PUBLIC INTEREST TECHNICAL REVIEW FOR GROUNDWATER APPLICATIONS

TO: Water Rights Section Date: 8/29/2025
FROM: Groundwater Section James Hootsmans
Reviewer's Name
SUBJECT: Application LL - 2014 Supersedes review of _____

Applicant's Name: TA Operating LLC County: Marion
Applicant(s) seek(s) 0.178 cfs from 1 well(s) in the Willamette Basin,
_____ subbasin
Proposed use Commercial - Truckstop Seasonality: year-round

Water-Level Measurements in Nearby Wells and Reasonably Stable Evaluations

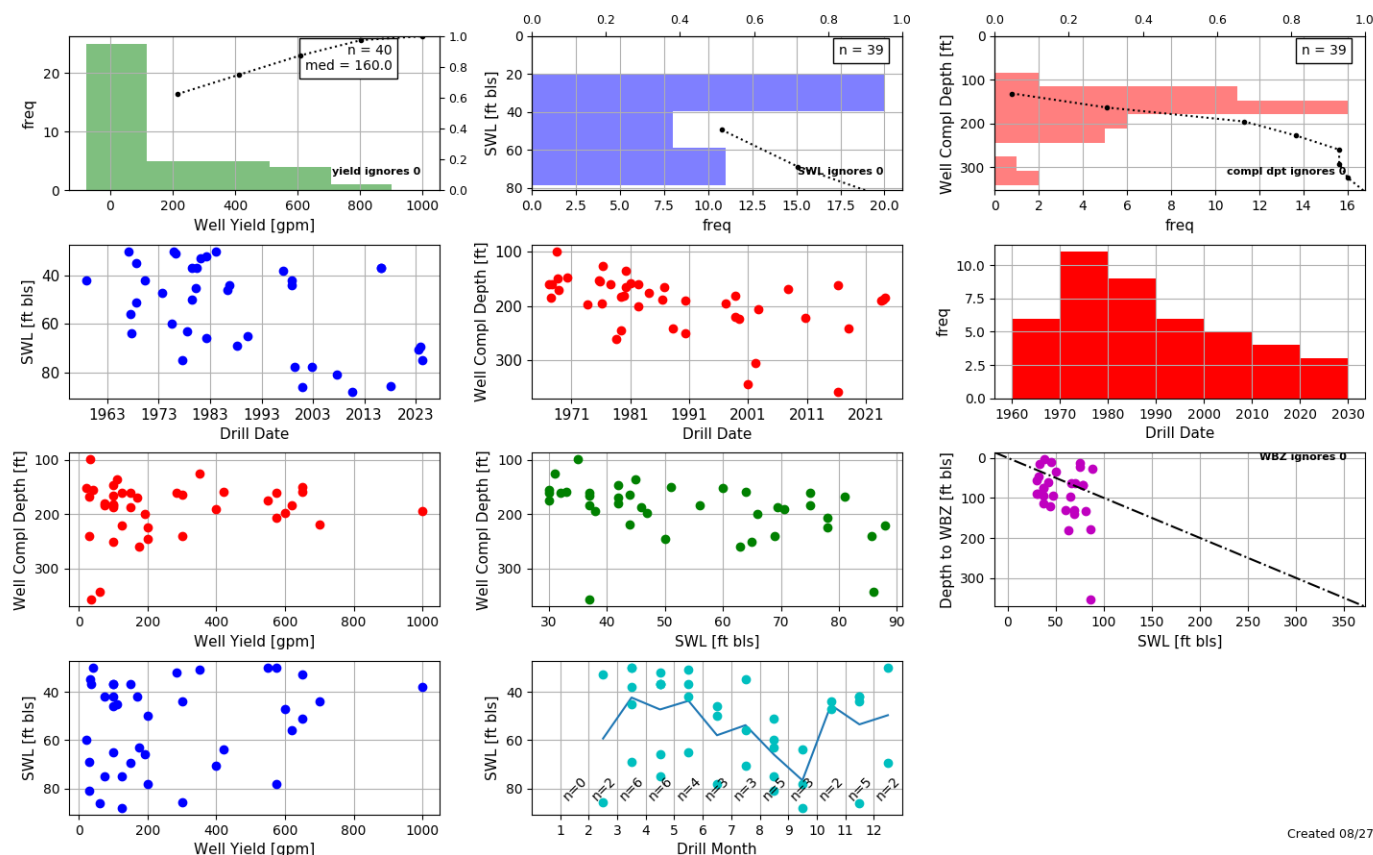
Comments: MARI 63260, the proposed POA on this application, did not have sufficient data to determine reasonable stability. The wells above are nearby basalt wells that are representative of the proposed POA.

Comments: Water levels in the basalt aquifer have been recovering since the City of Wilsonville stopped using their full groundwater rights in 2002. Water levels may drop again if the City ever executes their full rights. For the purpose of this limited license, the water levels are reasonably stable.
